Section 12A Rezoning Application No. Y/YL-MP/9

To Amend the Notes of the “Comprehensive Development to include Wetland Restoration Area” Zone for a Proposed Comprehensive Development at Wo Shang Wai, Yuen Long, Lots 77 and 50 S.A in DD101

Response to Comments (Batch 1)

28 May 2025

Direct line-of-sight from FN5 (~42mPD) to San Tin Highway:

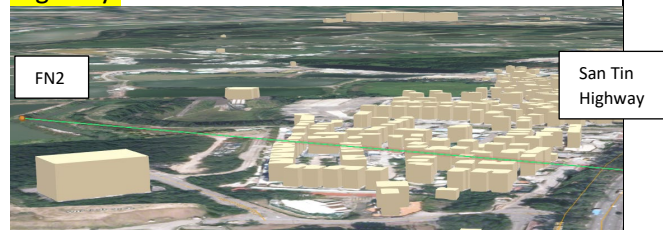
19. S.2.2.2: Please clarify the statement on “Error! Reference source not found”	Noted and revised in this updated revision.
20. S.2.2.2 – last 2 paragraphs: Most of the site will be separated from San Tin Highway by more than 300m with Royal Palms lying	Line-of-sight from FN7 (~21mPD) to San Tin Highway is partially screened:

between. Therefore, most of the site is unlikely be affected by San Tin Highway. Please justify the application of ASR “B” for the whole development. Besides, for the assessment of the planned fixed noise source, it is necessary to measure the background noise level for the determination of the appropriate noise criteria.

Please note that all representative NSRs for fixed noise assessment are within 300m from San Tin Highway and most of them have direct line-of-sight to San Tin Highway. Considering there are few NSRs with line-of-sight being partially screened, it is conservatively assumed that the site would be indirectly affected” by IF. Noise measurement is considered unnecessary as quantitative fixed noise assessment for planned fixed noise source was not conducted.
